AMENDMENTS TO THE DRAWINGS

App No.: 09/815,329

Title: CAPILLARY ARRAY ELECTROPHORESIS APPARATUS
AND ELECTROPHORESIS METHOD

FIG. 13C**FIG. 13A**(DETECTOR IS
BACK OF SHEET)**FIG. 13B**(DETECTOR IS
BACK OF SHEET)**FIG. 13D**(DETECTOR IS
BACK OF SHEET)

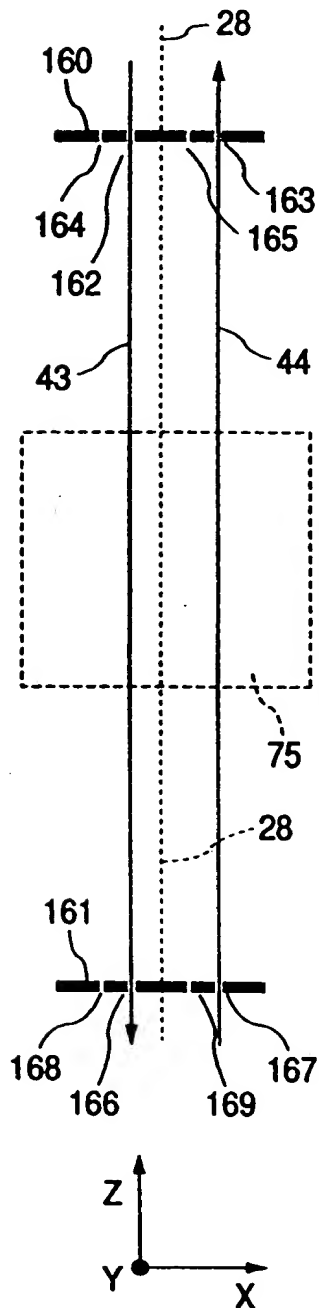
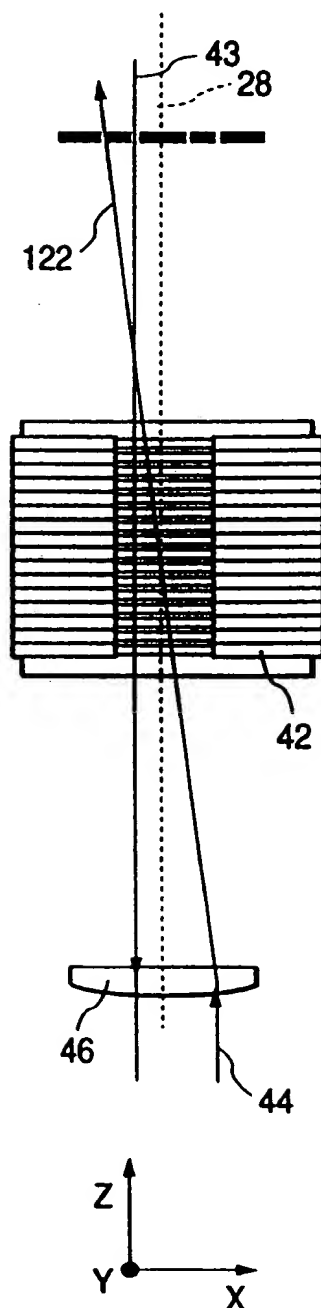
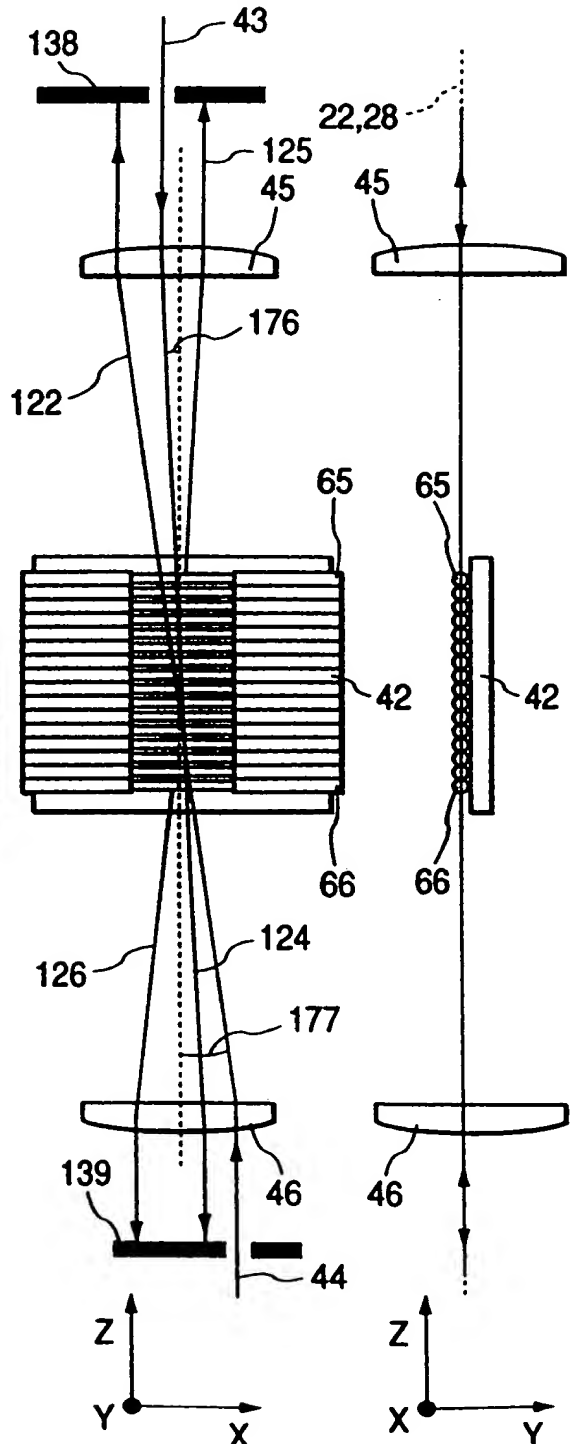
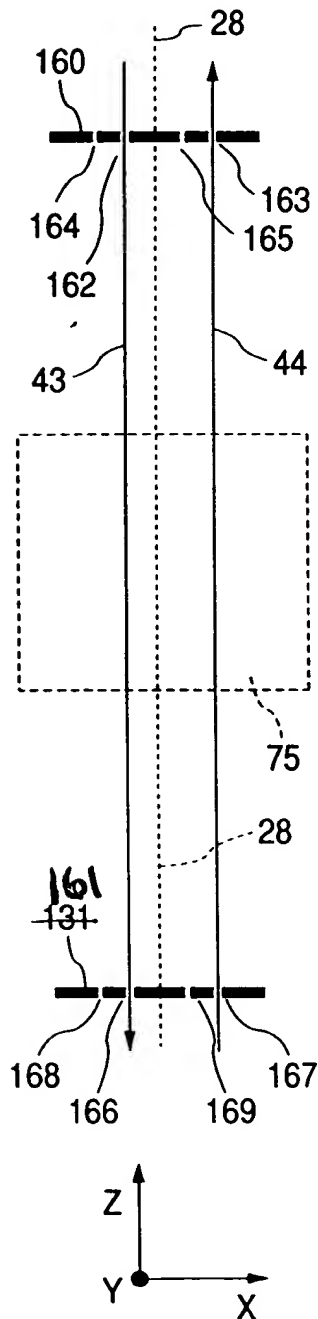
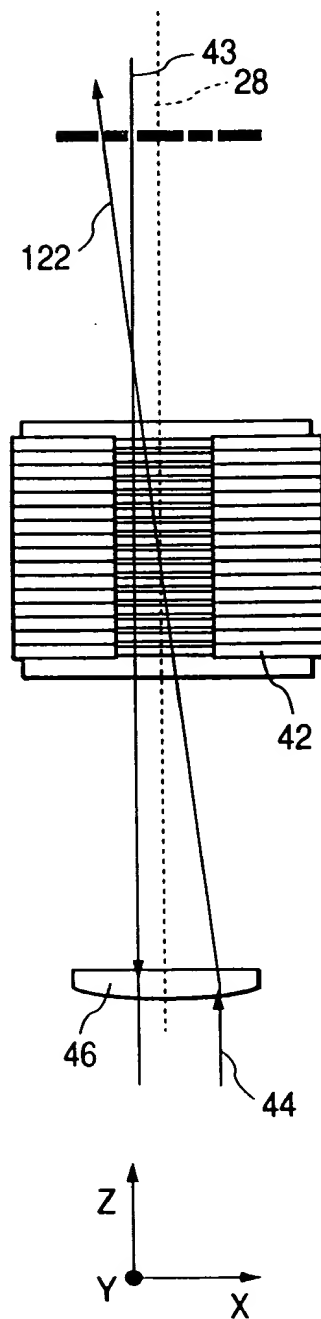
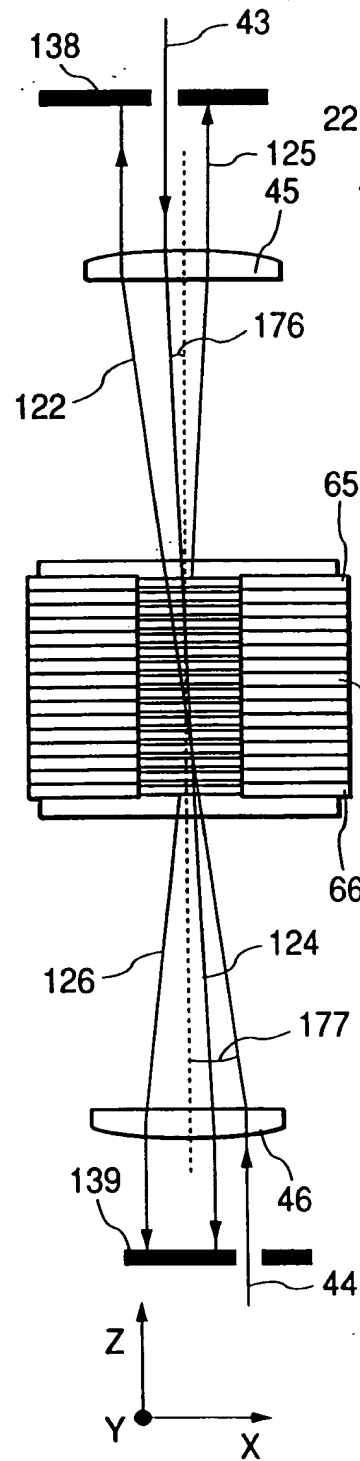
The attached sheets of drawings include changes to Figs. 13A and 14A. The changes, as requested by the Examiner, identify elements as described in the specification. Favorable consideration of the replacement drawings is respectfully requested.
